**METROPOLITAN GOVERNMENT OF NASHVILLE AND DAVIDSON COUNTY**

**STAFF RECOMMENDATION**  
**2203 Grantland Avenue**  
**May 15, 2013**

**Application:** Demolition—Outbuilding; New Construction—Outbuilding; Setback reduction

**District:** Woodland in Waverly Historic Preservation Zoning Overlay

SCALE: 1/4" = 1'-0"

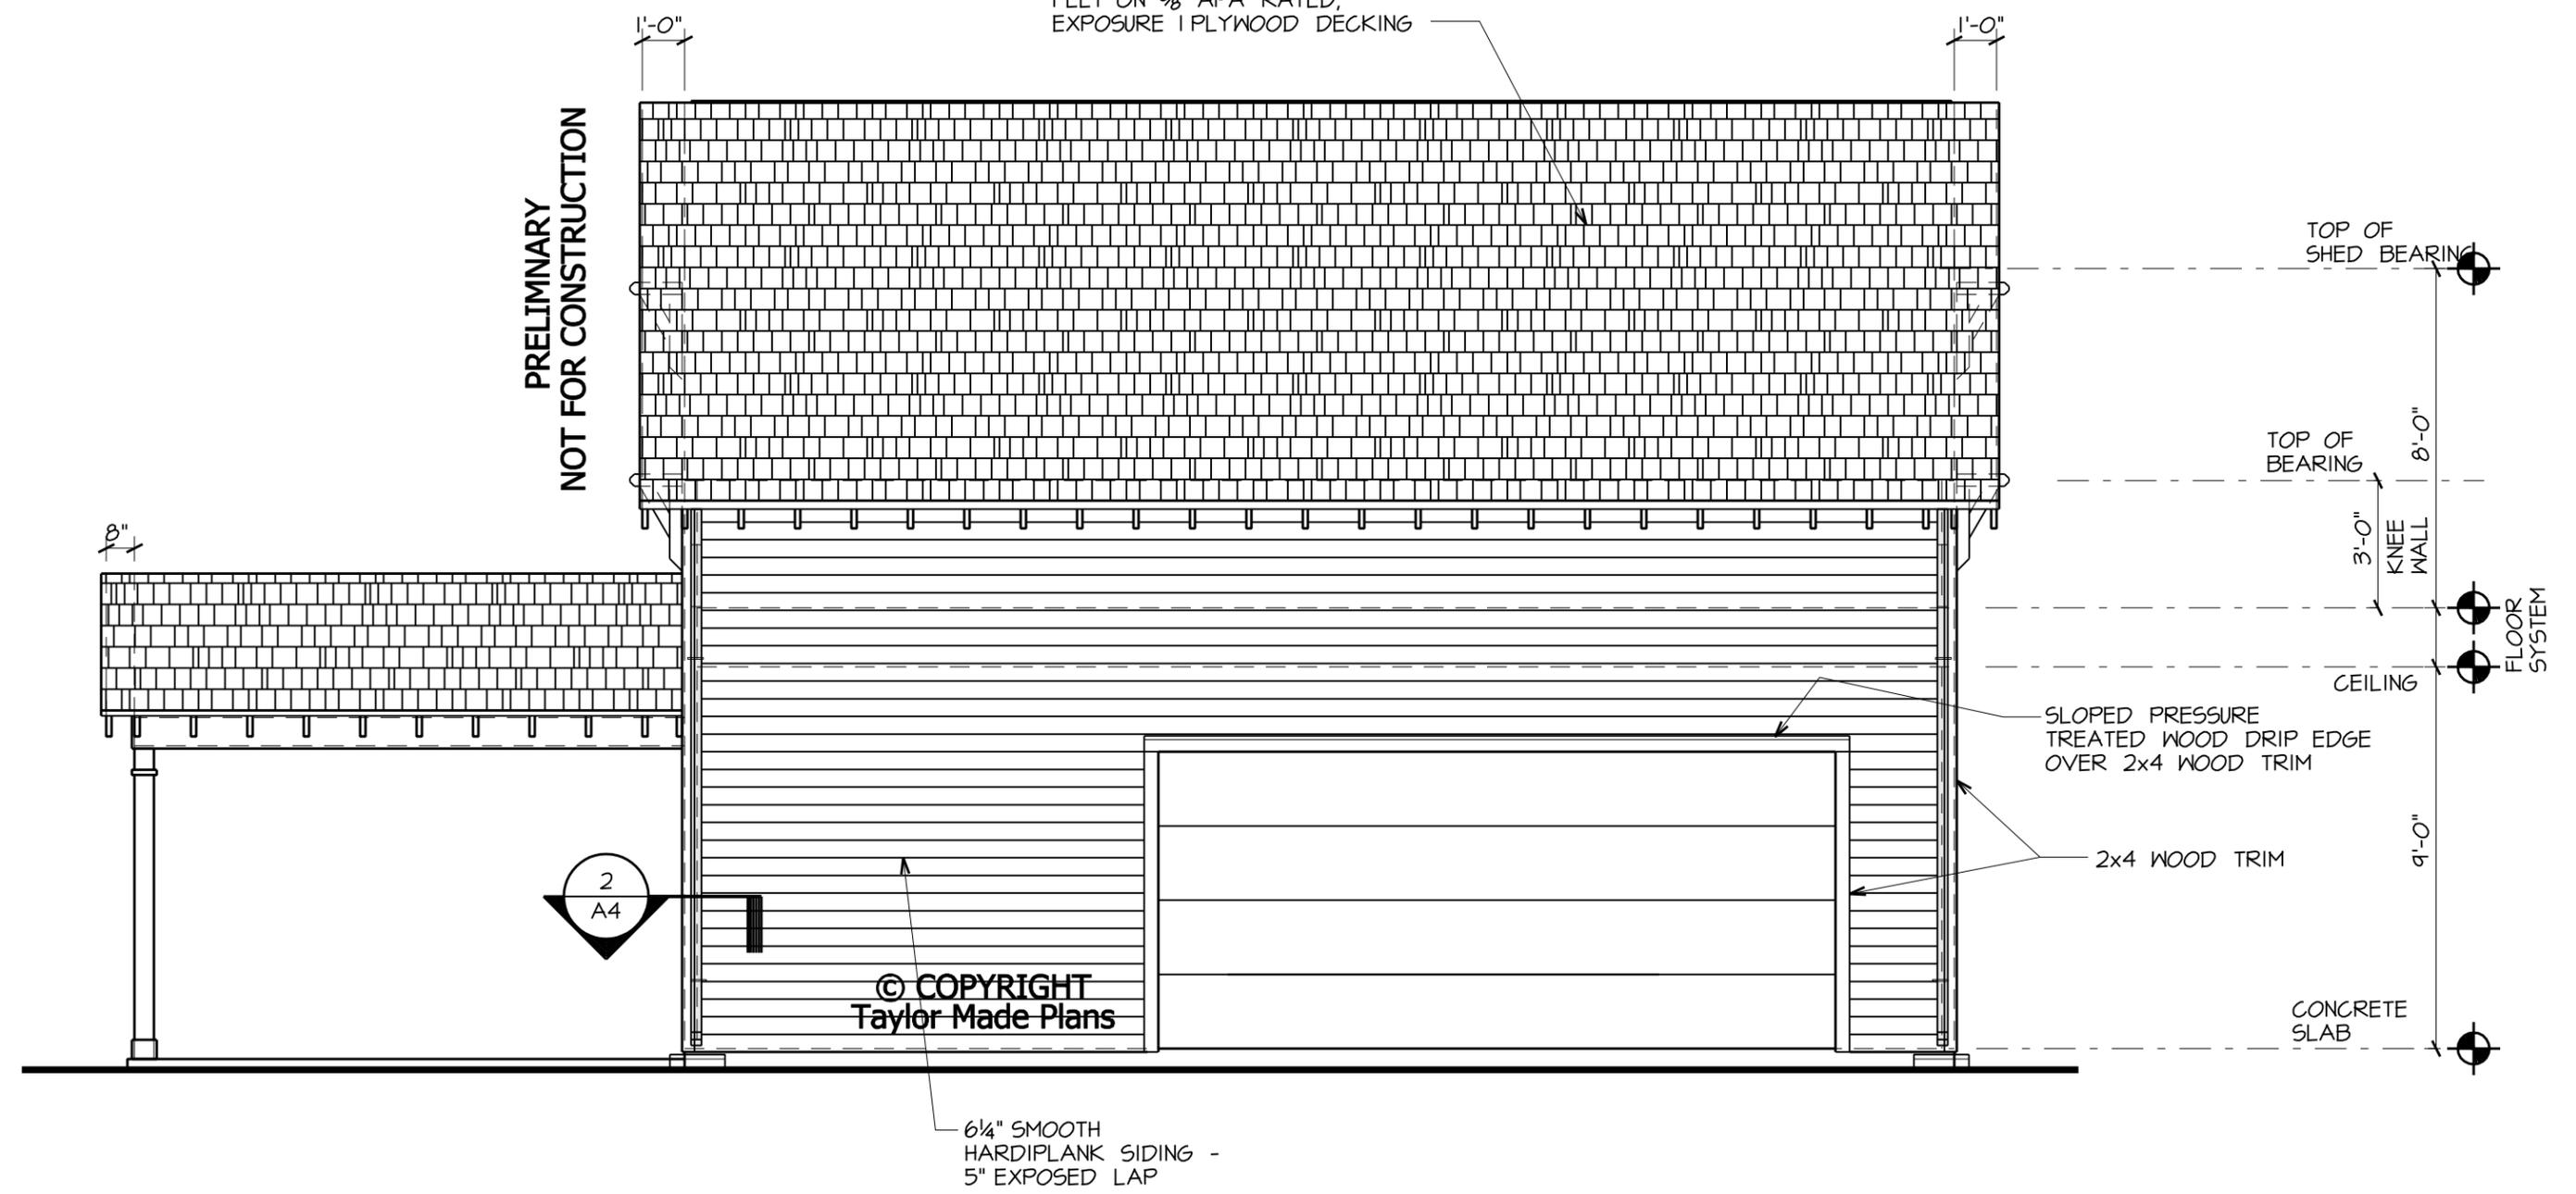
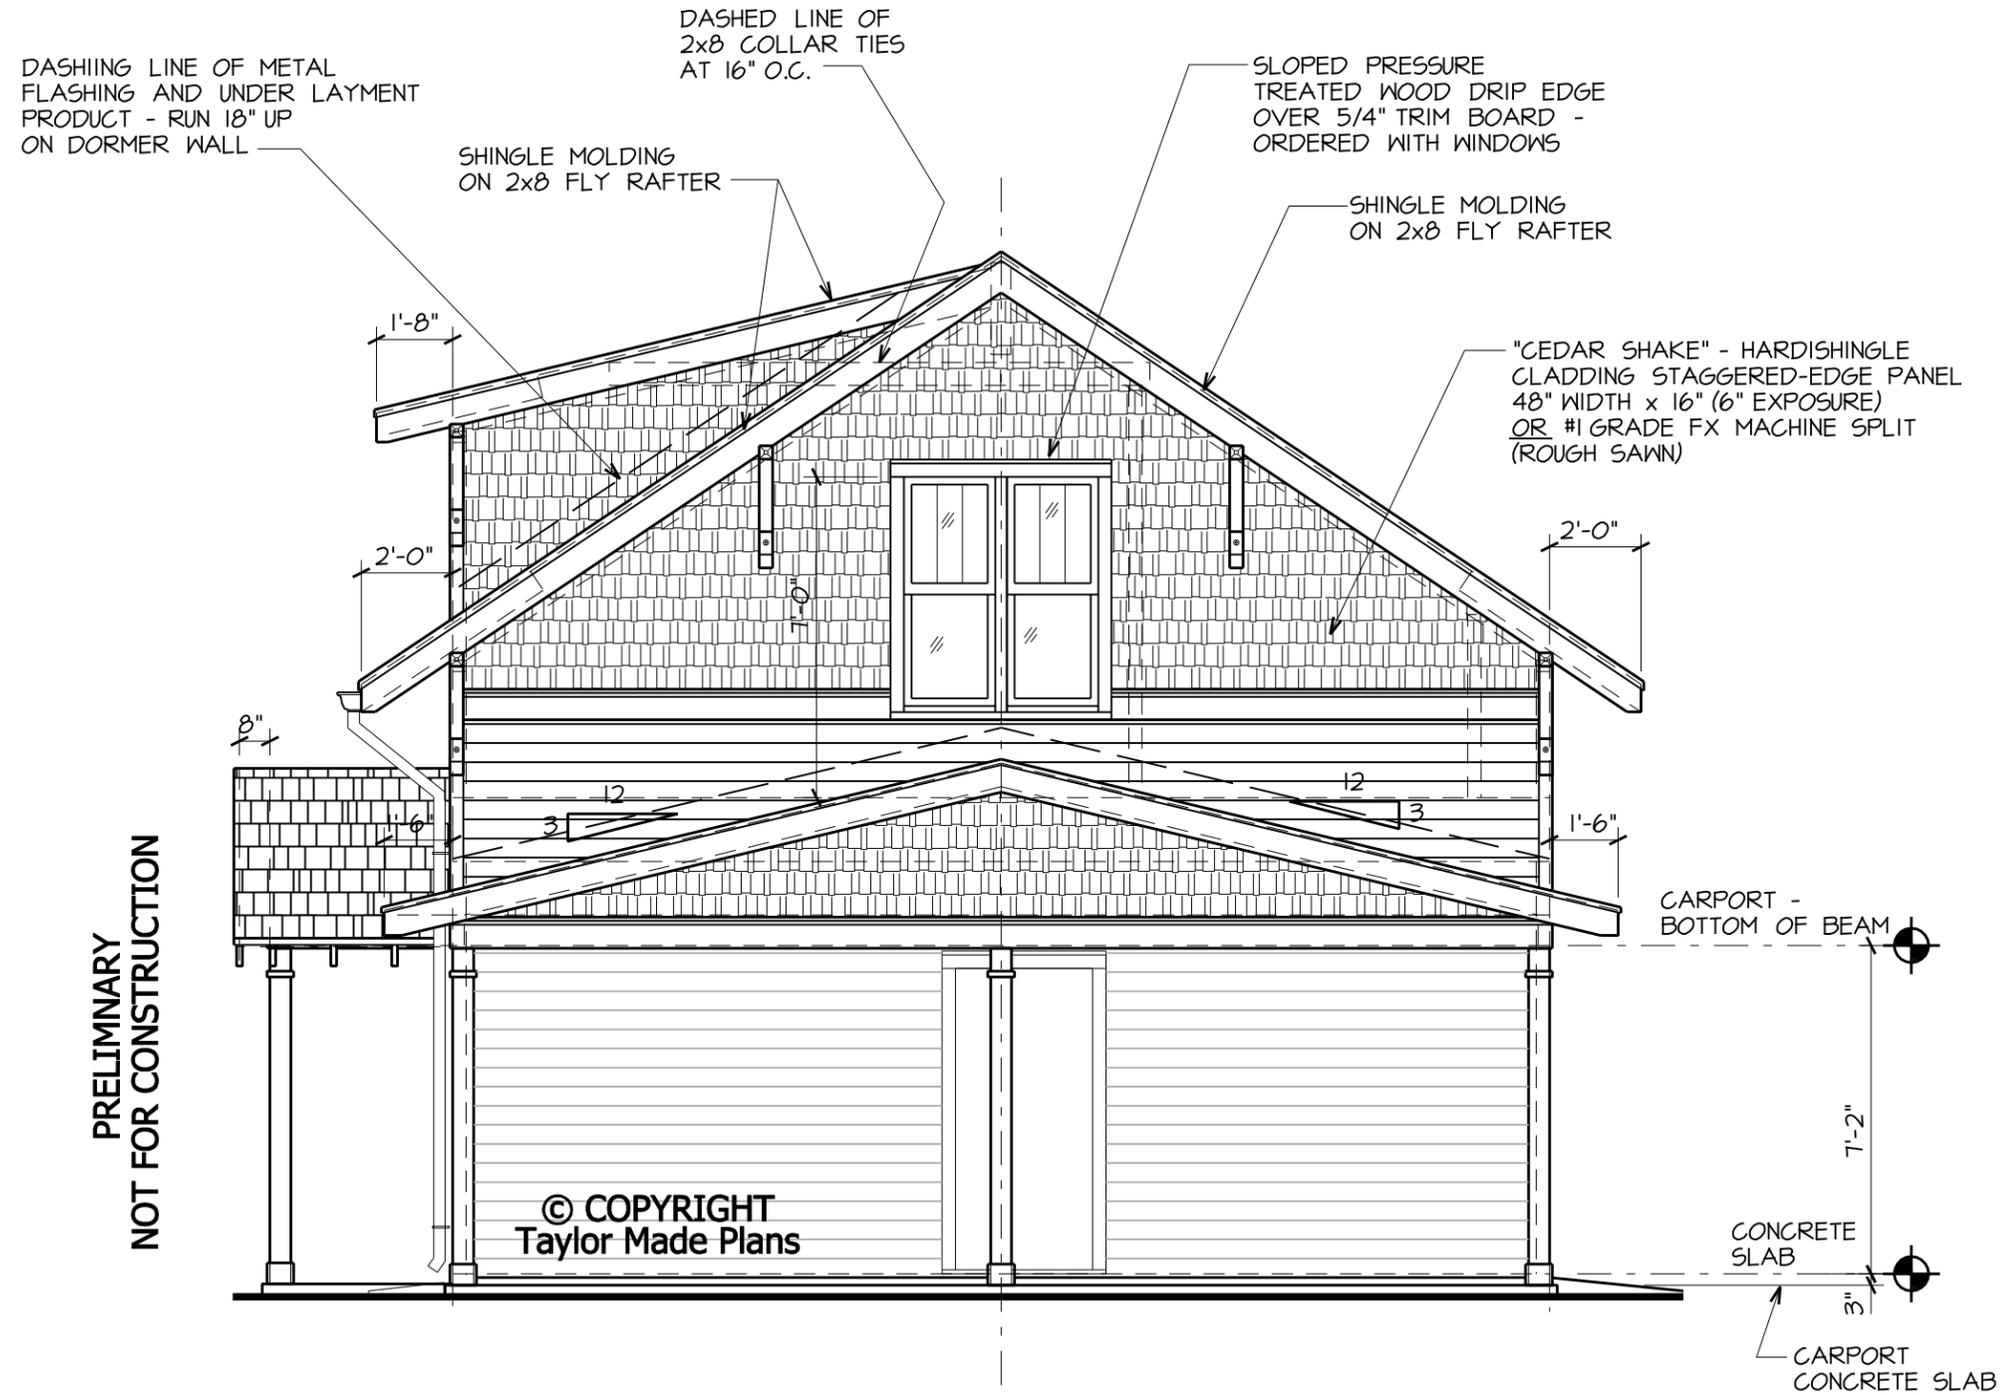
Height and Scale: The outbuilding has an enclosed garage element and an open carport element. The enclosed garage is one and a half stories with an eave height of approximately thirteen feet, three inches (13'3") from grade and a ridge height of approximately twenty-two feet, nine inches (22'9"). The enclosed garage is thirty feet (30') wide and twenty-four feet (24') deep, and therefore its footprint is seven hundred and twenty-four square feet (724 sq. ft.). The open carport element is one story in height with an eave height of approximately eight feet, five inches (8'5") and a ridge height of approximately eleven feet, eight inches (11'8"). The open carport element is thirteen feet (13') wide and twenty-four feet (24') deep, and therefore it has a footprint of three hundred and twelve square feet (312 sq. ft.). In total, the new structure will have a footprint of one thousand and thirty-six square feet (1,036 sq. ft.). This footprint is larger than typical outbuildings in the neighborhood, but staff finds it to meet the design guidelines because approximately one-third of the structure will be an open carport element that is only one-story in height. In addition, the footprint of the outbuilding is subordinate to that of the house, which has a footprint of approximately two thousand, four hundred square feet (2,400 sq. ft.). Staff also finds that the height of the outbuilding is subordinate to that of the house and does not contrast greatly with other outbuildings in the district. The addition of the outbuilding does seem to negatively affect the site's open space.

Materials: The known materials for the outbuilding have all been approved by the Commission in the past. The primary cladding material will be Hardiplank lap siding with a five inch (5") reveal. Hardishingle siding to mimic cedar shake will be used in the gable and dormer fields. The trim will be wood, the foundation will be a concrete slab, and the roof will be architectural shingles. Staff asks to review the shingle color. The materials for the windows, doors, and posts were not specified, and staff asks to approve them prior to purchase and installation. With the staff's final approval of the windows, doors, asphalt shingle color, and post material, staff finds that the materials meet Sections III.B.2.d. and III.B.2.h. of the *Woodland in Waverly Historic Zoning District: Handbook and Design Guidelines*

Roof Shape: The roof form for the enclosed portion of the outbuilding will be a side gable with a roof slope of 8/12. The structure includes a covered entryway with an 8/12 slope. The house-facing façade of the structure will have a shed dormer with 3/12 slope. The dormer is not inset from the wall of the structure, but that can be appropriate on an outbuilding. The covered carport portion of the addition will have a side gable with a slope of 3/12. The outbuilding's roof forms are all found in the district and are appropriate for an outbuilding. Staff finds that the roof form meets Sections III.B.2.e. and III.B.2.h. of the *Woodland in Waverly Historic Zoning District: Handbook and Design Guidelines*

Proportion and Rhythm of Openings. The structure's proportion and rhythm of openings are appropriate for a detached outbuilding in the rear of the lot. Staff therefore finds that the structure's proportion and rhythm of openings meet Sections III.B.2.g. and III.B.2.h. of the *Woodland in Waverly Historic Zoning District: Handbook and Design Guidelines*

**Recommendation Summary:** Staff recommends approval with the condition that staff approve the windows, doors, asphalt shingle color, and post material. With this condition, staff finds that the project meets III.B.2 and V.B.2. of the *Woodland in Waverly Historic Zoning District: Handbook and Design Guidelines*.
